APPEAL LODGED IN TERMS OF SECTION 79(2) OF THE STELLENBOSCH MUNICIPAL LAND USE PLANNING BY-LAW: APPLICATION FOR CONSENT USE ON FARM NO. 400, STELLENBOSCH DIVISION

DRAWING NUMBER:	BS2553
DATE COMPLETED:	12/07/24
ISSUED FOR:	PERMITTING
DRAWN BY:	T. RAMATABANE
SITE NAME:	POKADRAAI
DESCRIPTION:	Section Number 0480, VEELVERMAGT 400
ADDRESS:	001 POKADRAAI RD, Stellenbosch, 7624
COORDINATES:	LATITUDE: -33.595311°
OWNER NAME:	LONGITUDE: 18.738071°
DRAWING DESCRIPTION:	SITE PLAN

FARM 400, VEELVERJAAGT: MINOR ROAD 5208: APPLICATION FOR CONSENT USE TO ERECT A CELL PHONE TOWER (FORMALISATION)

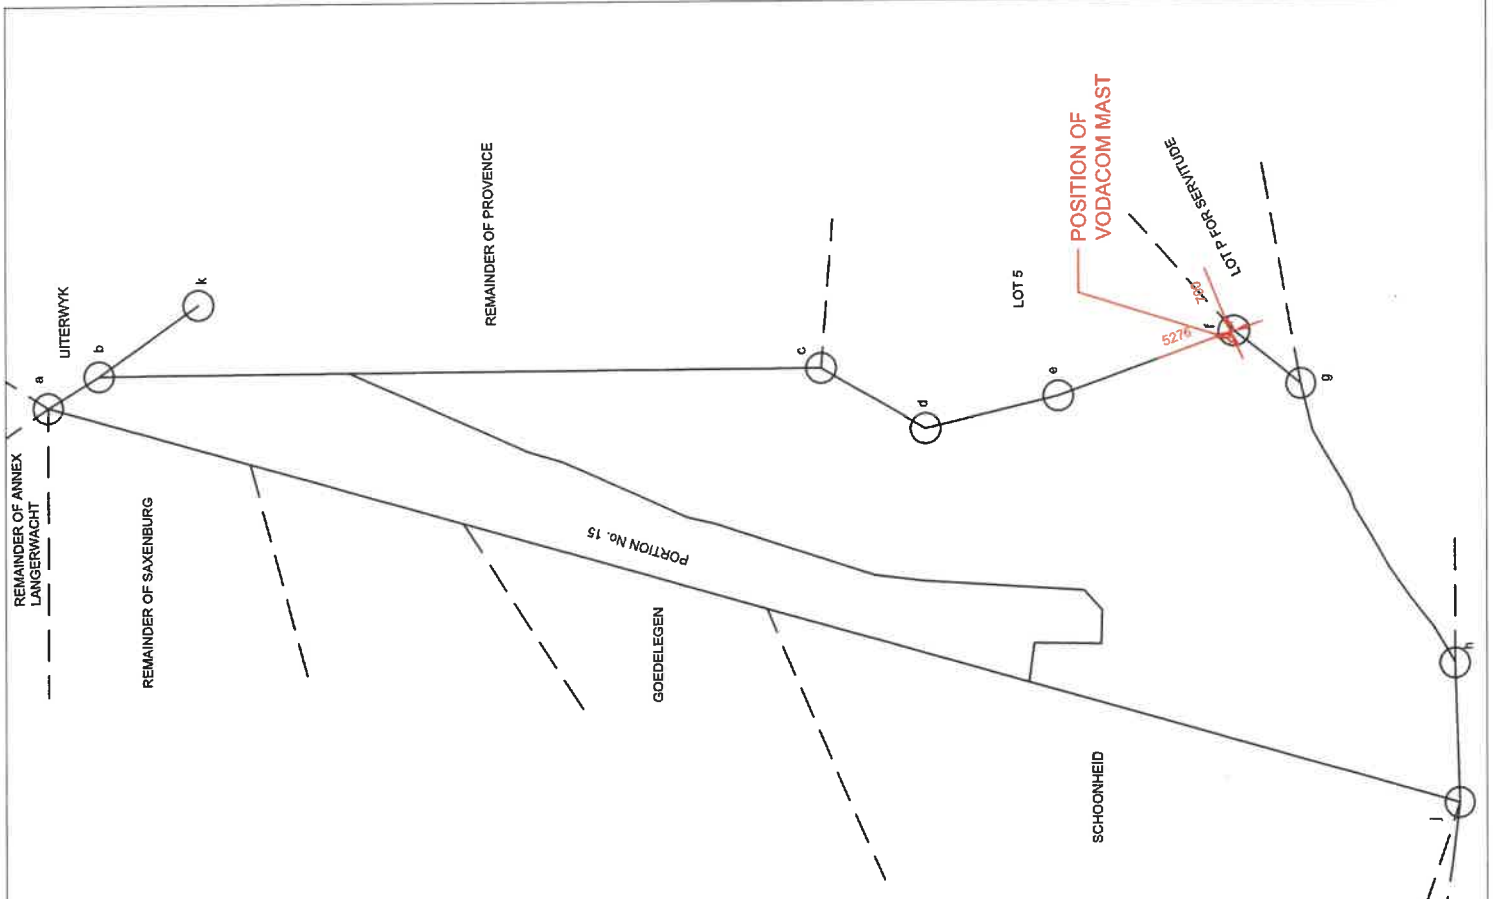
3. The application entails the formalisation of the existing Vodacom Telecommunication Infrastructure on the Farm 400, Stellenbosch.
4. The Site Development Plan (SDP) incorrectly indicates that the existing fence is approximately 9.3m from the road reserve boundary (16m of the proclaimed 20m road reserve is taken up) while it is approximately 3.0m.

6. Access to the cell phone tower is via a gravel road over Farm 400 from the existing access off OP5208 to the farm at $\pm$ km0.05 LHS.
7. The fence of the cell phone tower site encroaches on 5m building line by approximately 2m.

10. The shoulder sight distances (SSD) in both directions of the access comply with the minimum standards for a 60km/h design speed.
11. The Branch raises no objection to the application for the consent use of a cell phone tower on Farm 400, Stellenbosch, provided that the existing access off OP5208 at approximately km 0.05 (LHS) remains the sole access to the tower.
